**ENFORCEMENT CONFERENCE AGENDA  
DUKE POWER COMPANY  
9:30 A.M., JULY 1, 1988  
NRC/REGION II HEADQUARTERS BUILDING  
ATLANTA, GEORGIA  
ENVIRONMENTAL QUALIFICATION OF EQUIPMENT**

**ENFORCEMENT CONFERENCE AGENDA  
DUKE POWER COMPANY  
OCONEE NUCLEAR STATION  
9:30 A.M., JULY 1, 1988  
NRC/REGION II HEADQUARTERS BUILDING  
ATLANTA, GEORGIA  
ENVIRONMENTAL QUALIFICATION OF EQUIPMENT**

**ENFORCEMENT CONFERENCE AGENDA  
DUKE POWER COMPANY  
CATAWBA NUCLEAR STATION  
JULY 1, 1988  
NRC/REGION II HEADQUARTERS BUILDING  
ATLANTA, GEORGIA  
ENVIRONMENTAL QUALIFICATION OF EQUIPMENT**

**88-07-05 : MINCO RTDs - Termination  
Submergence**

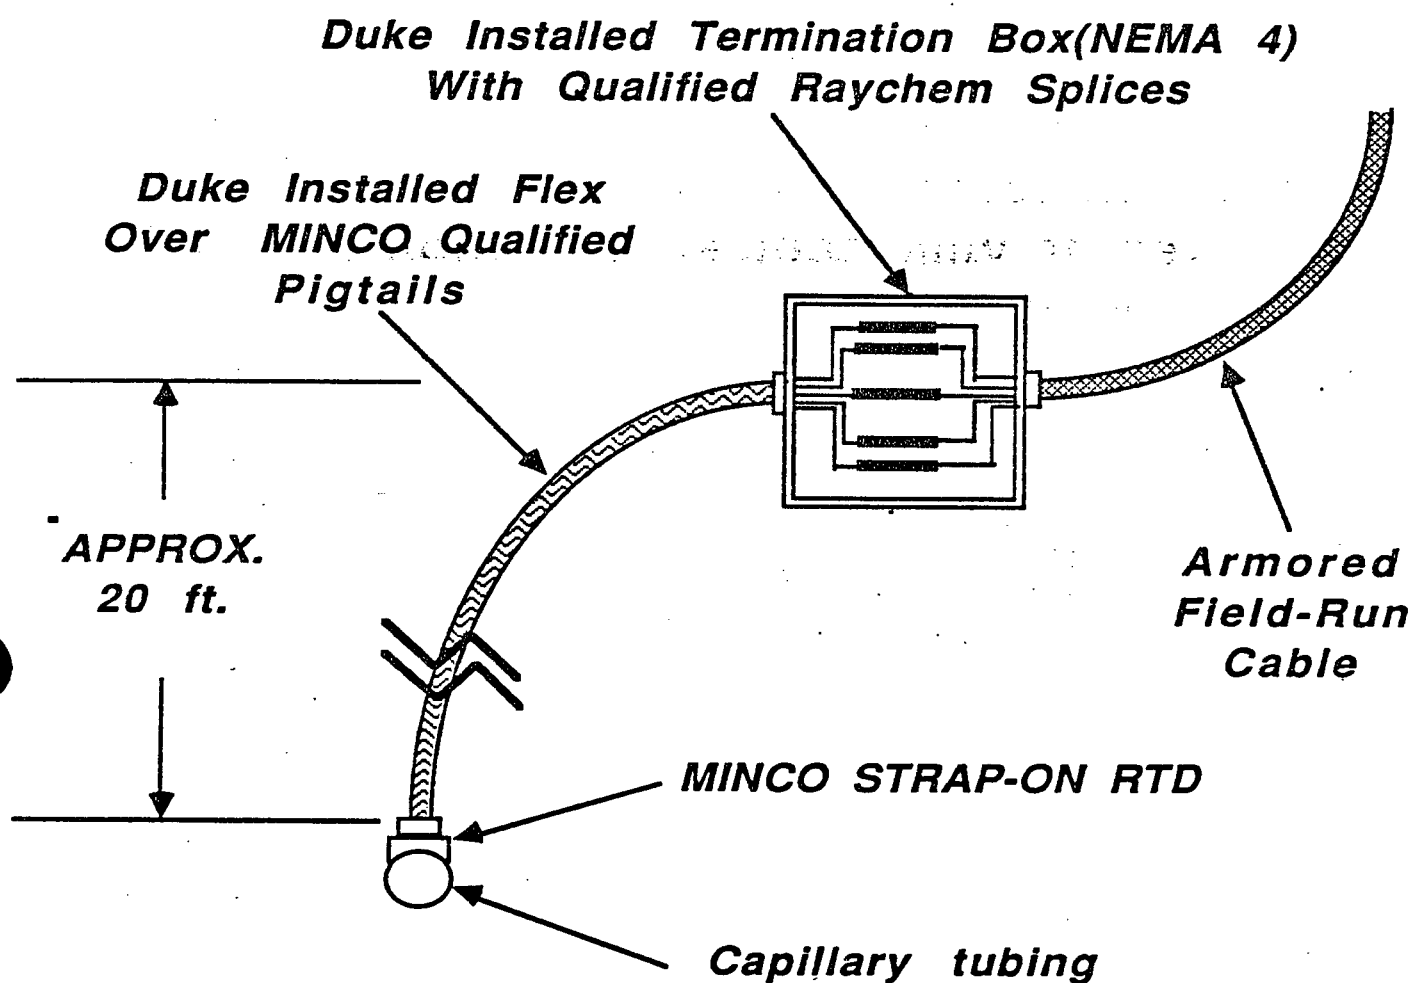
- **Inspector unable to physically examine the termination of the RTDs due to time restraint.**
- **Duke provided documentation demonstrating sufficient length of mineral insulated cable had been ordered with RTD to accommodate termination above flood level.**
- **Inspector expressed concern that he had observed installations at other utilities with cable coiled at termination box.**
- **During the inspection, the inspector indicated that information had been provided by another utility and, based on the inspector's knowledge of this application, the configuration should be qualifiable even if submerged.**
- **Duke walked down RTDs subsequent to inspection in response to inspectors concern.**

- **Duke notified NRC of walkdown results that some terminations were below flood level.**
- **Duke also provided the NRC with documentation and test performance data demonstrating the RTD terminations were qualifiable for submergence.**
- **Inspector found the method of qualification acceptable.**

## **88-07-06 : NAMCO Limit Switch Cover Gasket**

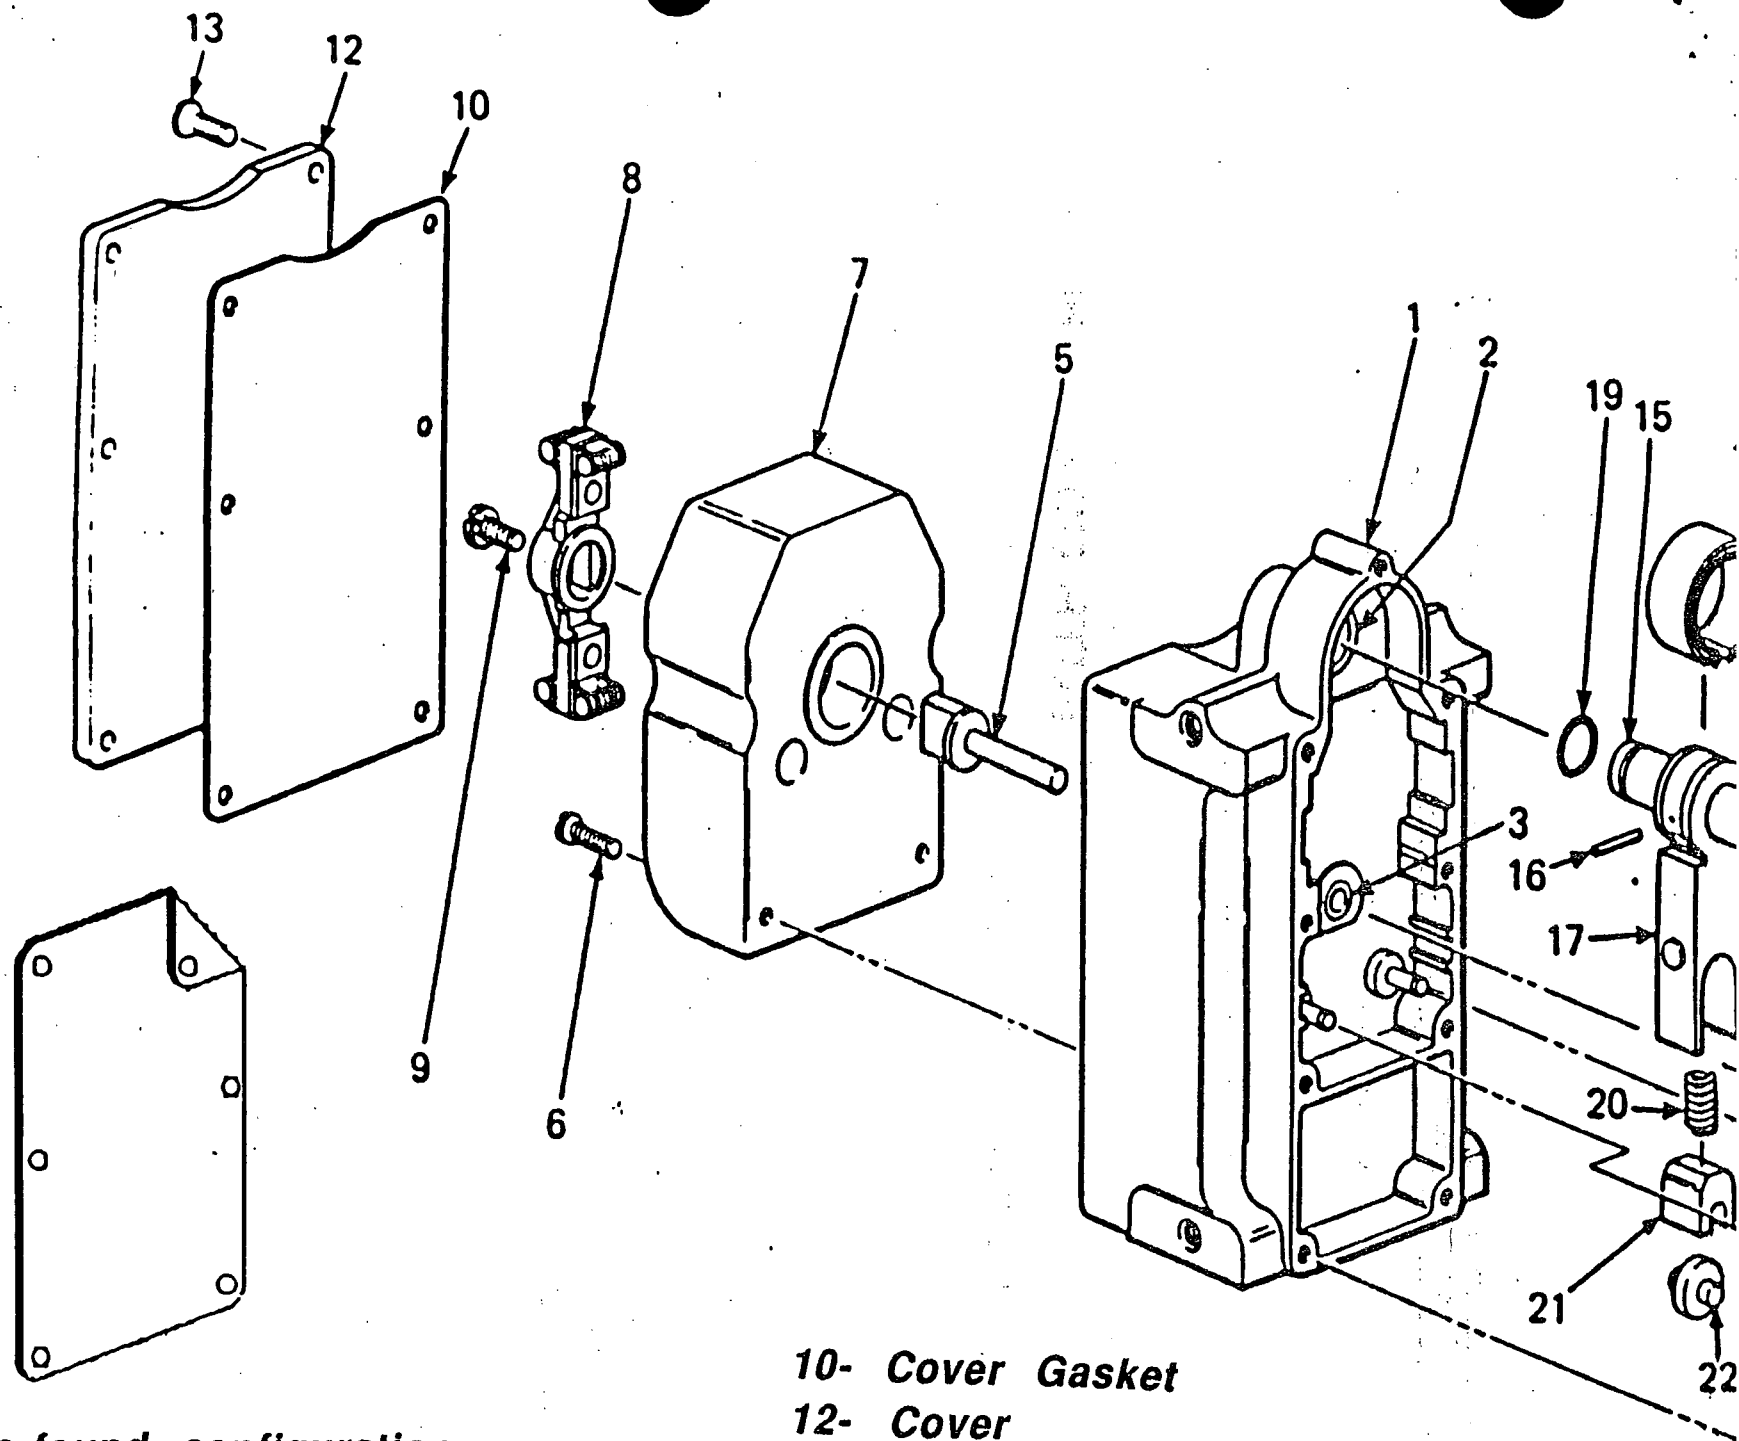
- **During the Unit 2 walkdown, a cover gasket was noted to be improperly installed(no other limit switches were found with installation deviations during the inspection).**
- **Evaluation of the function of the limit switch indicated the switch was not required to be on the Master List.**
- **The switches are included for maintenance consistency and conservatism.**
- **An inspection of accessible Unit 1 and 2 inside containment NAMCO limit switches and all Unit 2 switches required for control functions has been completed. None of these other switches were found with installation deviations.**

- **All remaining inside containment NAMCO limit switches will be inspected at next outage of sufficient duration.**
- **An inspection of the outside containment NAMCO limit switches has also been completed and although some problems were found and corrected, these switches were not required to be on the Master List. The NRC was notified by courtesy call.**
- **Installation procedures have been refined/revised to preclude a recurrence of this situation.**
- **This item was specifically addressed during subsequent station technician EQ training.**
